Staff Report: PHO-2-22--Z-47-17-8

**APPLICATION #**: PHO-2-22--Z-47-17-8

**REQUEST:** 1) Modification of Stipulation 1 regarding general conformance

2) Review of conceptual elevations by the Planning Hearing

# **EXHIBIT G**

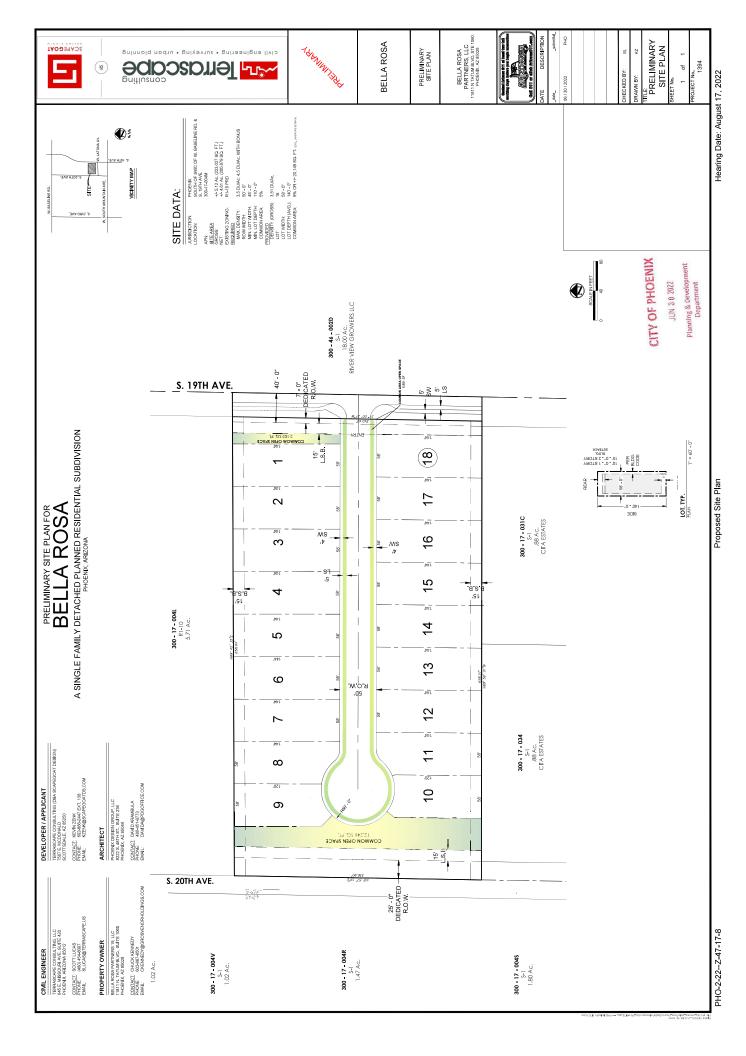
The proposed conceptual site plan depicts an 18-unit single-family subdivision at approximately 3.51 dwelling units per gross acre, with approximately 9% open space. Units are arranged along a street running east/west through the site. The street terminates in a cul-de-sac along the west property line. Most of the open space is along the west property line. The proposal is substantially similar to the stipulated site plan, with the caveat that it is designed with less than half of the original area. The density remains below, and the open space above, Ordinance standards. The proposal is compatible with existing development in the surrounding area.

A new sub-stipulation is recommended requiring staggered front setbacks. This recommendation is consistent with the recommendation of the South Mountain Village Planning Committee. It is also consistent with design recommendations in the Rio Montaña Area Plan (Page 39, Figure 71).

sta stip	The development shall be in general conformance with the site plan date stamped JUNE 30, 2022 July 28, 2017, as modified by the following stipulations and approved by the Planning and Development Department, WITH SPECIFIC REGARD TO THE FOLLOWING:	
A.	THE SITE PLAN SHALL DEPICT STAGGERED FRONT SETBACKS FOR COVERED BUILDING ELEMENTS, SUCH THAT ANY TWO ADJACENT LOTS SHALL PROVIDE A MINIMUM VARIATION IN FRONT SETBACK OF 4 FEET.

# **EXHIBIT H**

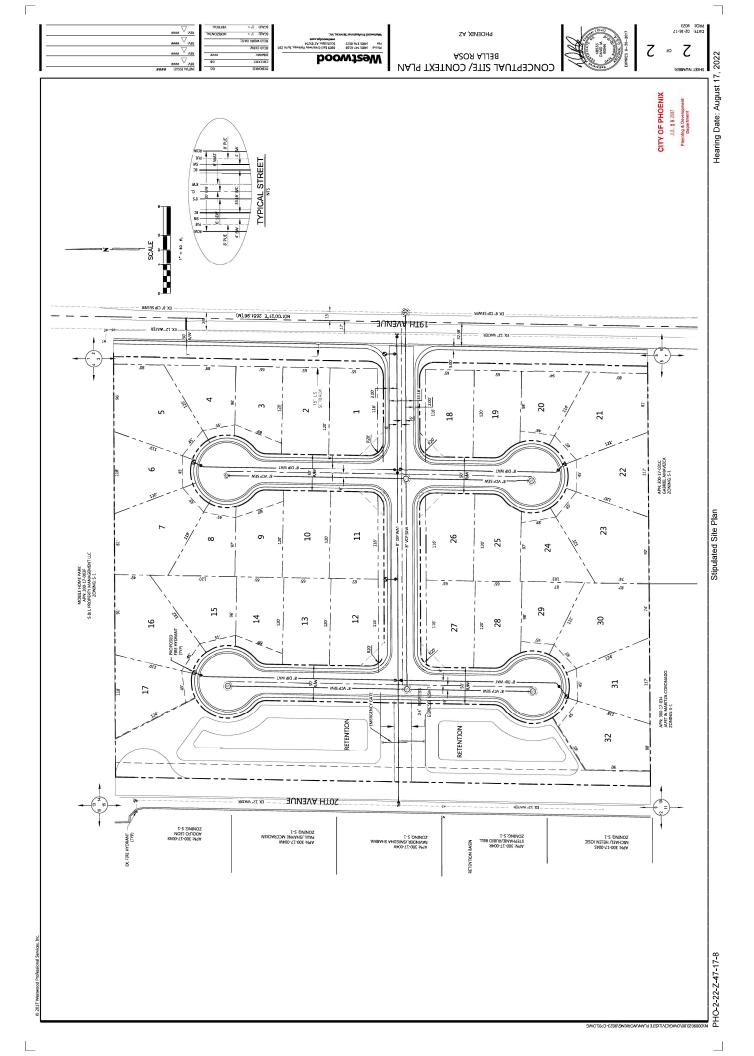
The applicant requested modification of Stipulation 1 regarding general conformance with the site plan date stamped July 28, 2017. The stipulated site plan (Exhibit H) depicted a 32-unit subdivision at a density of approximately 3.03 dwelling units per gross acre on the full 11.15 gross acres of the original rezoning case area. Approximately 15 dwelling units were depicted on the southern half of the site. The proposed conceptual site plan (Exhibit G) depicts an 18-unit single-family subdivision at approximately 3.51 dwelling units per gross acre. A single street terminating in a cul-de-sac on the western edge of the site is proposed, and approximately 9 percent of the gross area would be reserved for common area open space. The lots are 58 feet wide with minor variations around the cul-de-sac.

The subject property includes only the southern 5.12 gross acres of the 11.15 gross acres rezoned in the original case. The stipulated site plan depicted a 32-unit single-family subdivision at approximately 3.03 dwelling units per gross acre and approximately 13.9% open space. Units were arranged around four cul-desacs oriented north/south, with most of the open space along the west property line. The street running east/west through the site terminated in an emergency gate along the west property line.

# **EXHIBIT I**

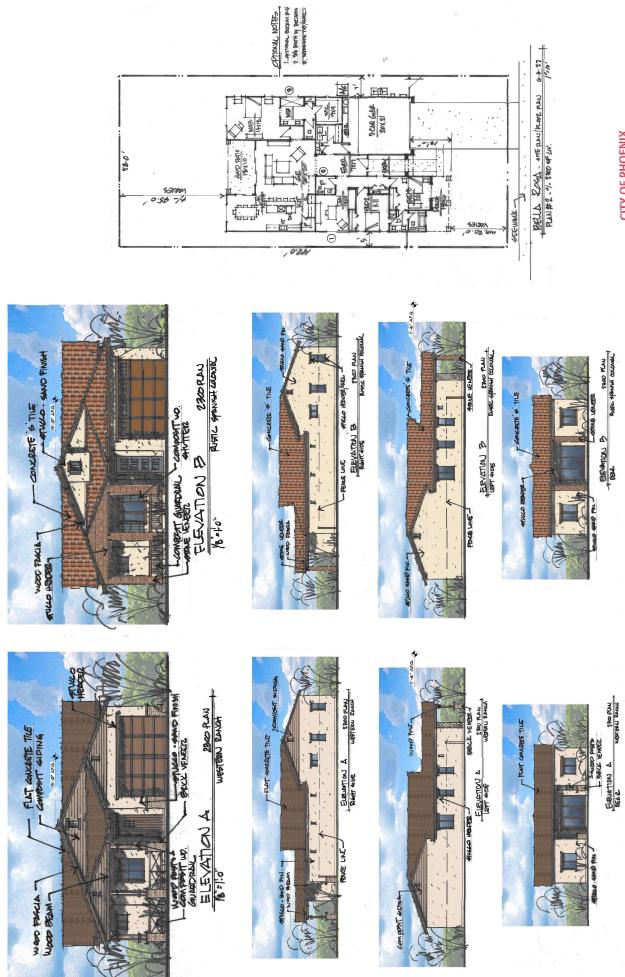
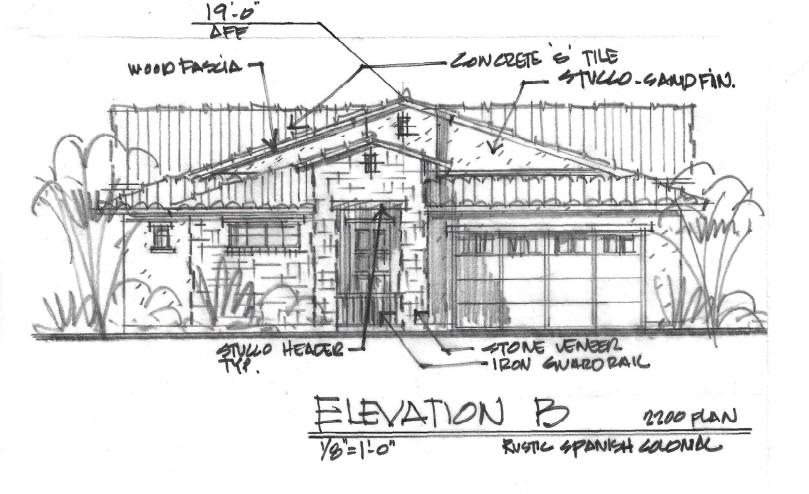
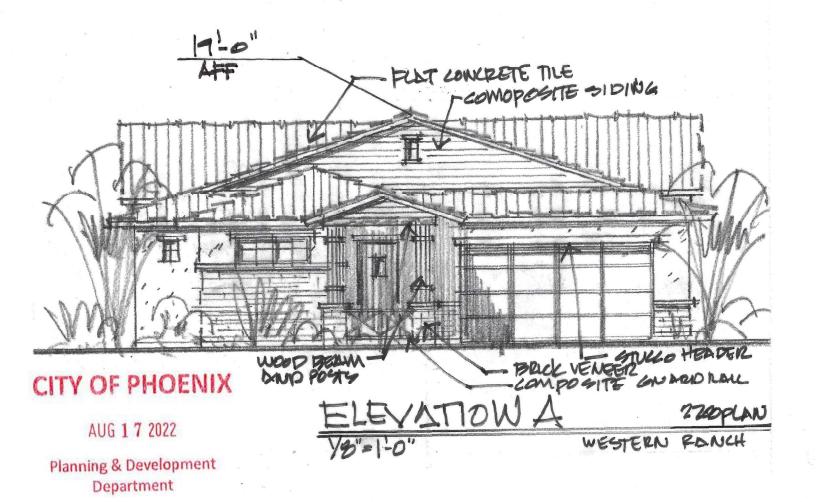
3) The applicant submitted conceptual elevations for review and approval per the requirements of Stipulation 4. The stipulation has been complied with and is recommended to be deleted and replaced with a standard language stipulation for general conformance to the elevations provided. Stipulation 4 states that the elevations submitted should be consistent with recommendations in the Rio Montaña Area Plan. The elevations depict a variety of building materials (stone façade, composite siding, wood elements, brick veneer), multiple building colors, variation in roof design, and multiple architectural features (wood posts, gable ornamentation, varied window sizes, decorative garage panels). This diversity is

consistent with the Rio Montaña Area Plan and many of the design choices are compatible with the rural and agricultural character described in the plan.

**Mr. Valencia** presented the elevations while bringing out that some key areas include reduction of garage dominance which could be done by stepping back the garage which all the elevations seem to indicate. Mr. Valencia stated that side loaded garages are closer to the front property line but break up garage dominance because it has windows and acts like a faux front. Mr. Valencia stated that none of the elevations indicate side loaded garages so of the committee wants that they will have to give some specifics such as percentage of elevations to provide that option. Mr. Valencia next mentioned front porches are also characteristic of the Rio Montaña Area Plan and that all the proposed elevations do not indicate porches or their dimensions. All elevations indicate pitched roofs which Mr. Valencia said was another Rio Montaña Area Plan character trait. As well as the variety of materials being proposed.

**Kevin Zenk** mentioned that side loaded garages would be difficult to achieve on lots of this width because of turning radius requirements. Mr. Zenk added that they are accepting of the front porch requirements as it does create more massing and reduces the prominence of the garage. **Chair Daniels** replied that she has seen smaller lots with side loaded garages.

5.	COVERED PORCHES A MINIMUM OF SIXTY SQUARE FEET IN AREA AT A DEPTH OF AT LEAST SIX FEET SHALL BE PROVIDED IN THE FRONT YARD OF FIFTY PERCENT OF THE HOMES IN A SUBDIVISION. NO PORCH SHALL TERMINATE WITHIN THE PLANE OF A DOOR OR WINDOW.
